Technical Memorandum

Ref: 16-002518-WTM02-Rev3

Subject: Covella - Water Precinct Network Plan Amendments

Covella - Water Precinct Network Plan Amendments

Attachment 2: Drawing Nos. 18-000185-600, 602 & 610.

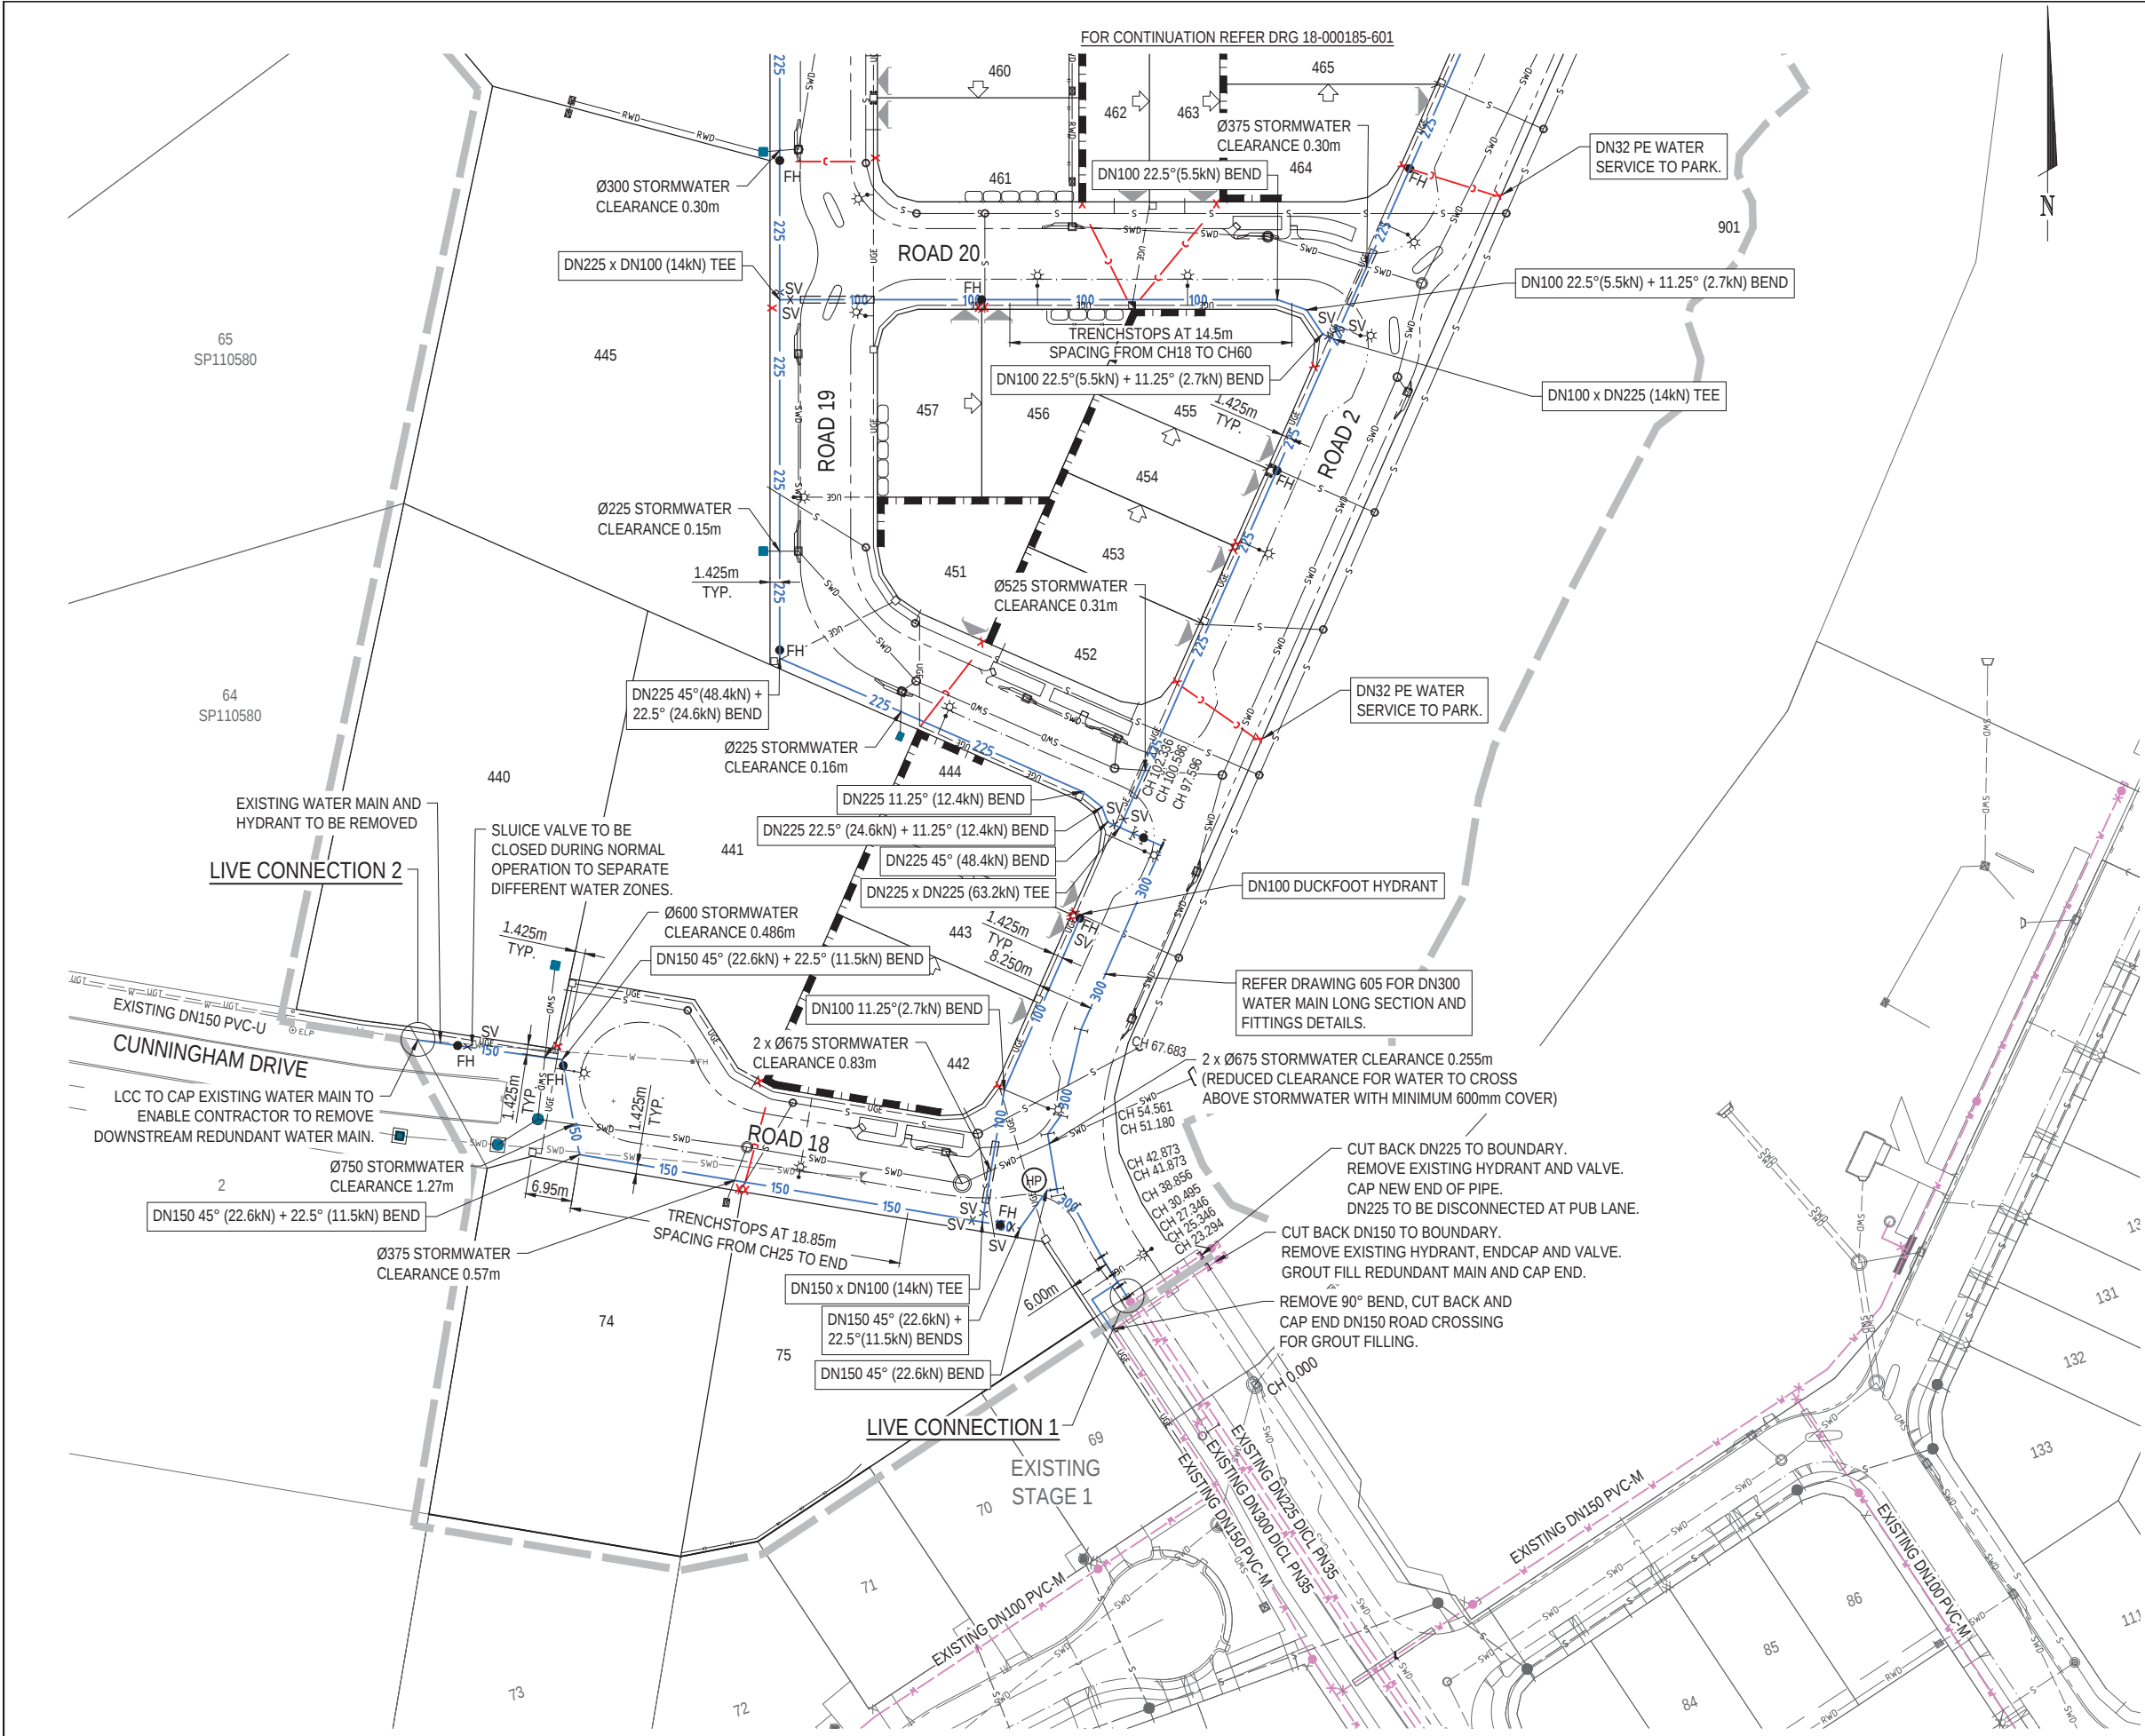
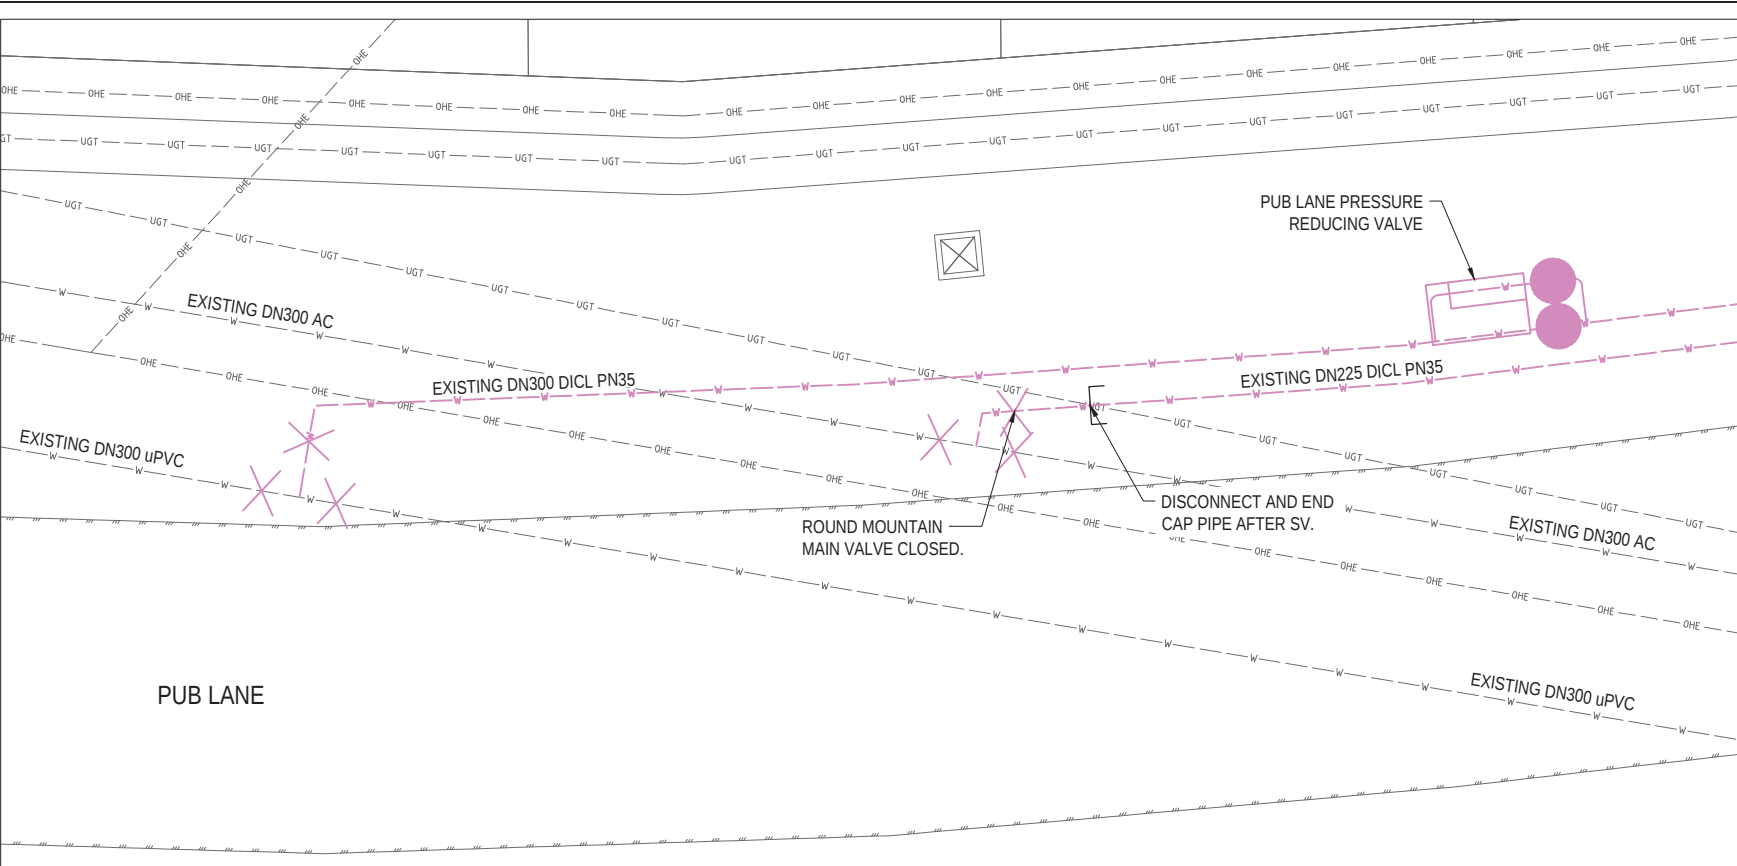
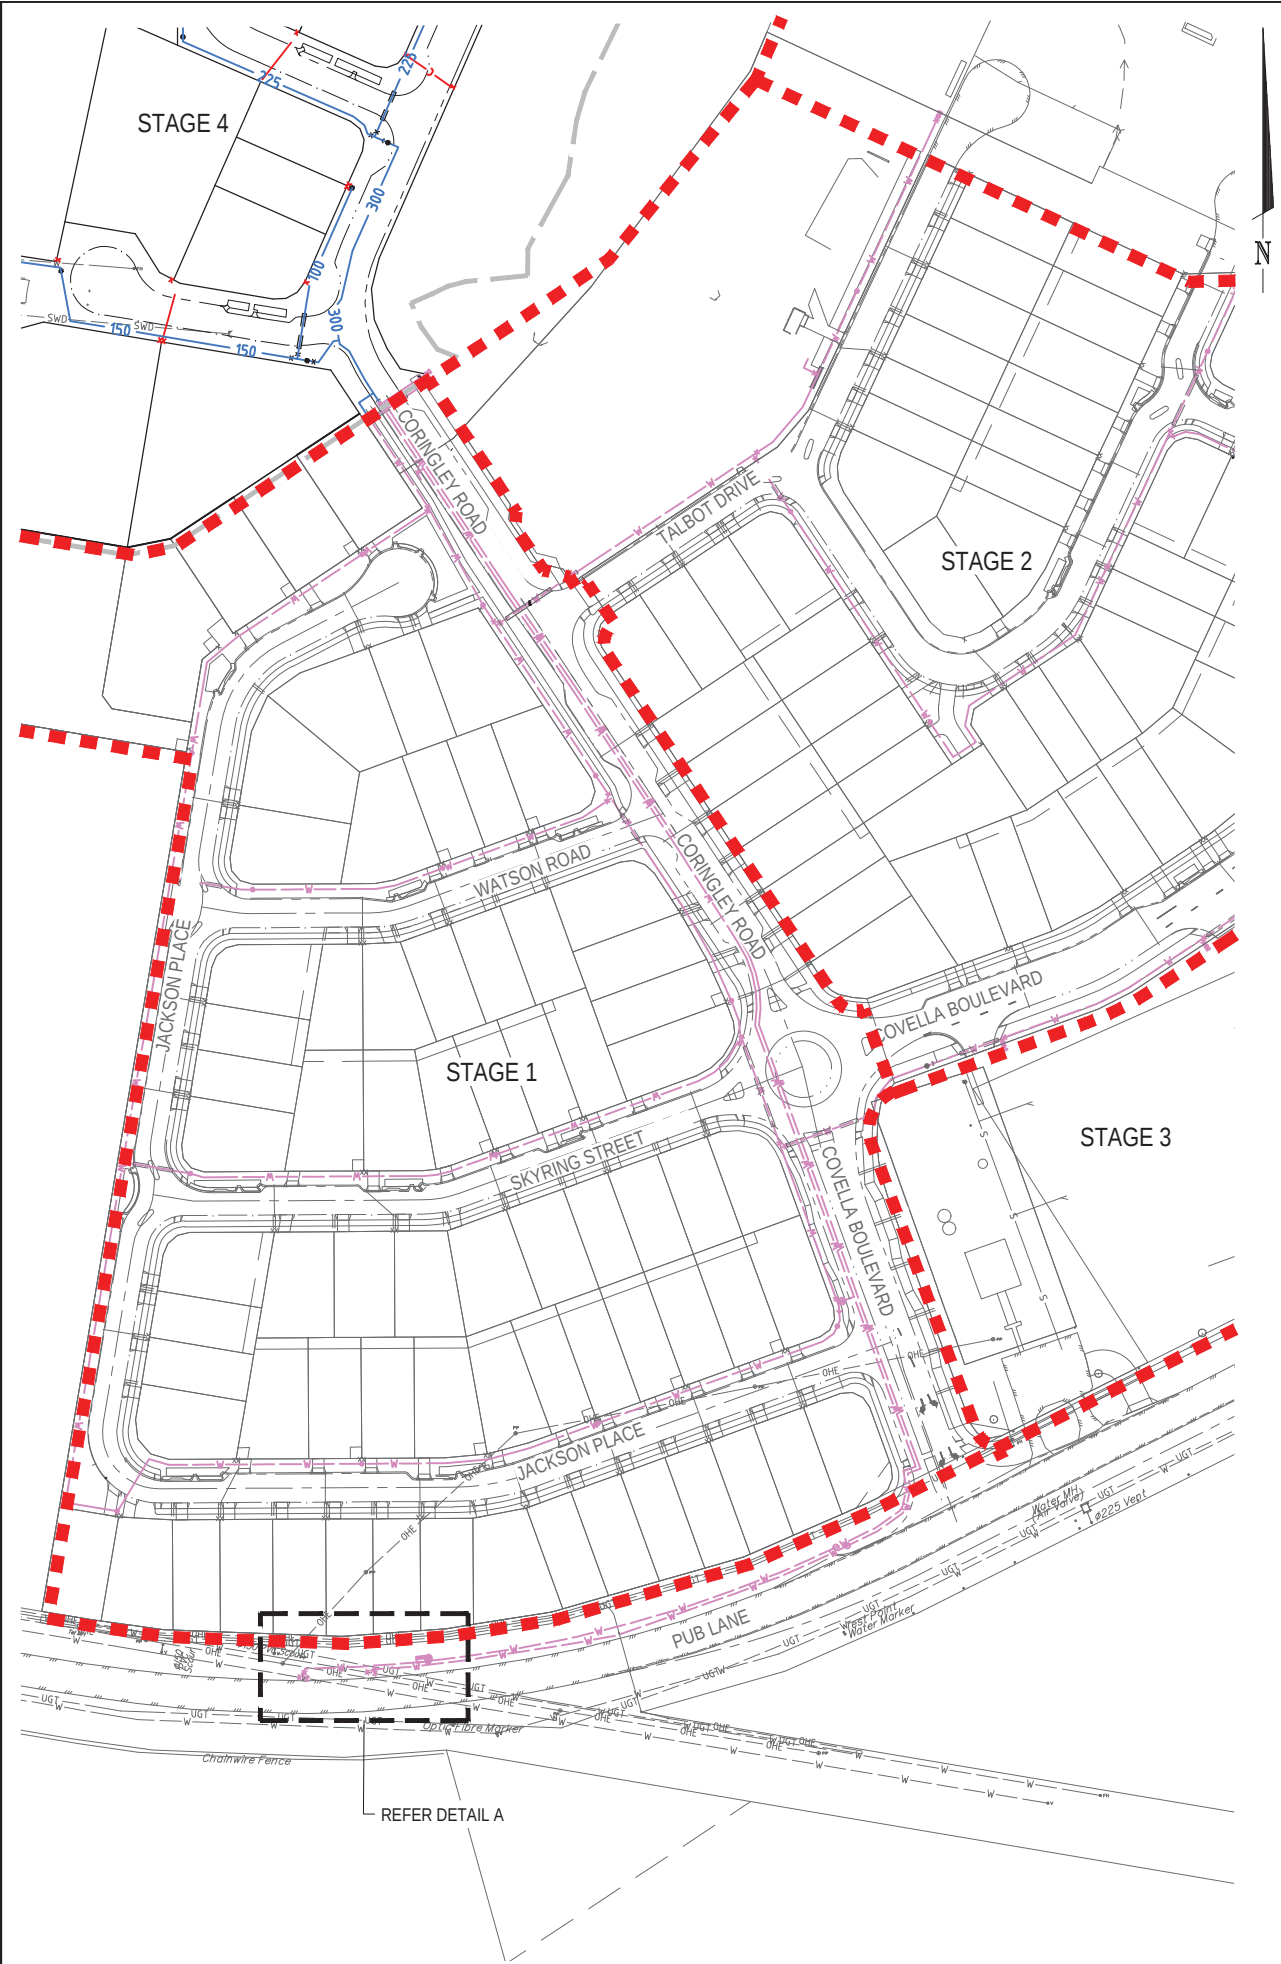
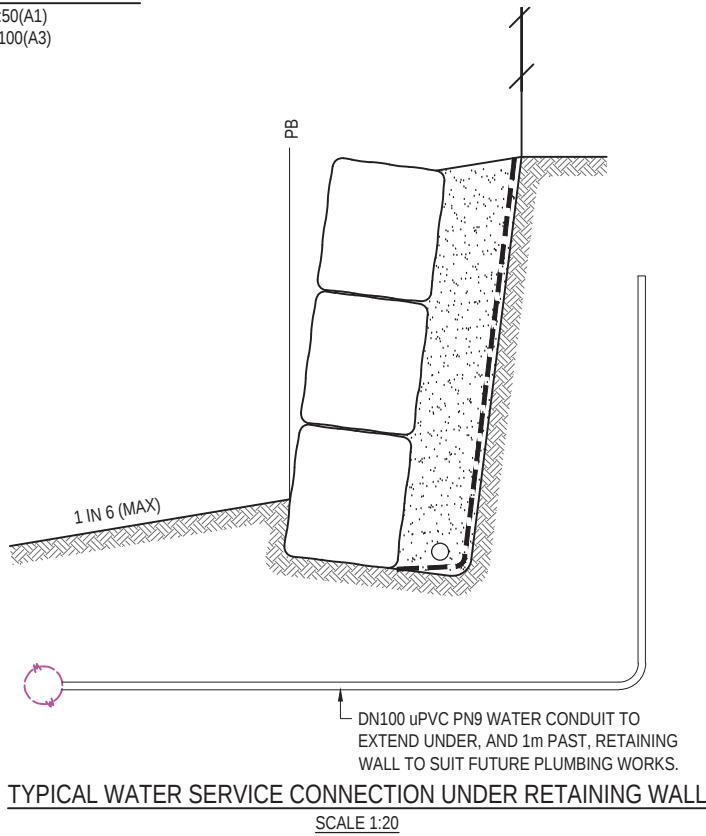
The proposed reconfiguration of exiting water supply infrastructure is illustrated on Drawing Nos. 18-000185-600, 602 and 610 included within Attachment 2. It is proposed that the existing DN300 (DACL) and DN150 (PVC-M) water mains will remain operational with a new cross connection provided at the boundary of Stage 4. The existing DN225 (DACL) water main will be disconnected and decommissioned with cap ends installed. Considering the age and material of this existing asset, Calibre recommend against grout filling the pipeline as it may offer an opportunity for future reuse as a service conduit or similar.
